CONSTRUCTION PLAN
HOH WAREHOUSE
LOT 4, BLOCK 6,
BAKKER LANDING 1ST ADDITION
TEA, LINCOLN COUNTY, SOUTH DAKOTA

Plan Review Provided by:
LOOKOUT PLAN + CODE CONSULTING
Tom Paisley
605-639-0190
ICC Certified Plans Examiner No. 0876040-60
1/31/2025

See attached building Code Review and plan sheet comments

C-100

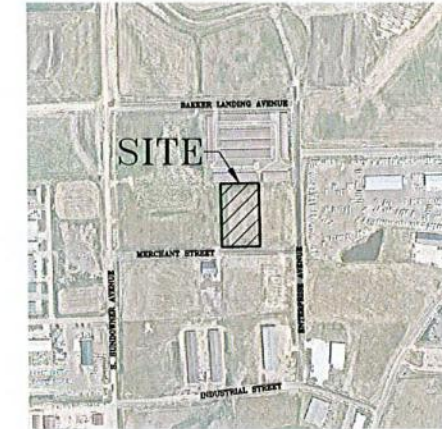
FG LINE - VERIFY
MATCHES C-401

ADD SILL HT DIM.
EGRESS ANALYSIS

ADD PITCH CALLOUT
(APPEARS 4:12)

ADD BLDG HT DIM.
ON ALL ELEVATIONS

REQ'D FOR PERMIT

DR HDR 7'-0" -
MIN 7'-4" IBC
1010.1.1. FIX.

WAINSCOT
LABEL 4'-0" /
GRAPHIC 3'-6"?

SPEC PANEL MFR,
TYPE & COLOR
